Access Compliance Report

Public Rights-of-Way

(Curb Ramps)

Intersection ID: 18963	Main Street: GROVER_RD	Cross Street: SOUTH_BV	Location: NW
ADA ID: 2260D5834459	Ramp Type: PerpDiag	Initial Pass/Fail: Fail	Overall Compliance: No
Severity Score: 22.5			
Codes/Mitigation Info/Possible Solution		Field Measurements/Component Compliance

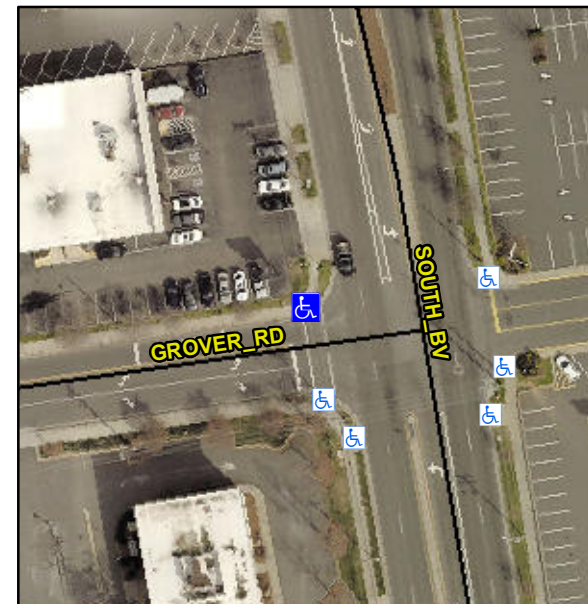
Not Found, R304.5.1, R304.2.2, R304.5.3

Compliance	Description	Data	Compliance	Description	Data
N/A	Ramp Length (in)	84.0	No	Ramp Slope (%)	9.6
No	Ramp Width (in)	47.0	No	Ramp XSlope (%)	2.3
N/A	Flare Type LT	N/A	N/A	Flare Type RT	N/A
N/A	Flare Slope LT (%)	N/A	N/A	Flare Slope RT (%)	N/A
N/A	Flare Traversable LT?	N/A	N/A	Flare Traversable RT?	N/A
N/A	Landing Length (in)	N/A	N/A	DWS Provided?	N/A
N/A	Landing Width (in)	N/A	N/A	DWS Contrast?	N/A
N/A	Landing Slope (%)	N/A	N/A	DWS Length (in)	N/A
N/A	Landing X Slope (%)	N/A	N/A	DWS Full Width?	N/A
N/A	Landing Curb? (Y/N)	N/A	N/A	DWS Offset (in)	N/A
N/A	Shared Landing?	N/A			
N/A	Gutter Ponding?	N/A	N/A	Gutter Slope (%)	N/A
N/A	Gutter Lip Ht (in)	N/A	N/A	Gutter X Slope (%)	N/A
N/A	Painted X Walk1?	Yes	N/A	Painted X Walk2?	No
	X Walk 1 Direction	To S		X Walk 2 Direction	To E
N/A	X Walk 1 Width (in)	110.0	N/A	X Walk 2 Width (in)	N/A
	X Walk 1 Slope (%)	1.7		X Walk 2 Slope (%)	1.2
	X Walk 1 X Slope (%)	1.1		X Walk 2 X Slope (%)	0.1

Remove & Replace Curb Ramp With Two New Directional Ramps or Equivalent.
